# United States Patent and Trademark Office

| APPLICATION NO.                             | FILING DATE     | FIRST NAMED INVENTOR   | ATTORNEY DOCKET NO.     | CONFIRMATION NO |
|---|-----------------|------------------------|-------------------------|-----------------|
| 10/008,766                                  | 11/07/2001      | Robert H. Mimlitch III | 50097-00003PT 9188      |                 |

| . 1  |   |   |                 |  |  |  |
|--|---|---|-----------------|--|--|--|
| Office Action  | n Summary   | Examiner  | Art Unit        |  |  |  |

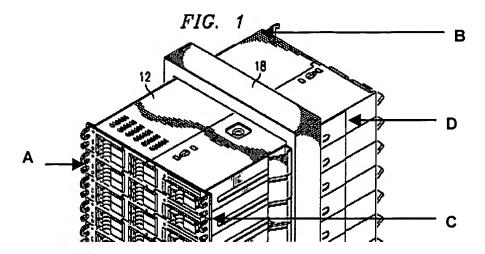
As to claim 52, Jensen et al. disclose a method for adapting a two-post equipment rack to support four-post loads, comprising:

coupling a first coupling member 20 to a first post 16;

coupling a second coupling member 20 to a second post 16;

coupling a third coupling member 20 to a first post 16 substantially planar to (the first and third coupling members lie within the same plane) and substantially parallel to a first coupling member 20;

coupling a fourth coupling member 20 to a second post 16 substantially planar to (the second and fourth coupling members lie within the same plane) and substantially parallel to the second coupling member; and

wherein each of the coupling members emulate one respective post **A,B,C,D**(Figure 1 reprinted below with annotations) in a four-post rack, with each emulate post defining a supporting point for a load (via the hole in flange **30**; Figure 1).
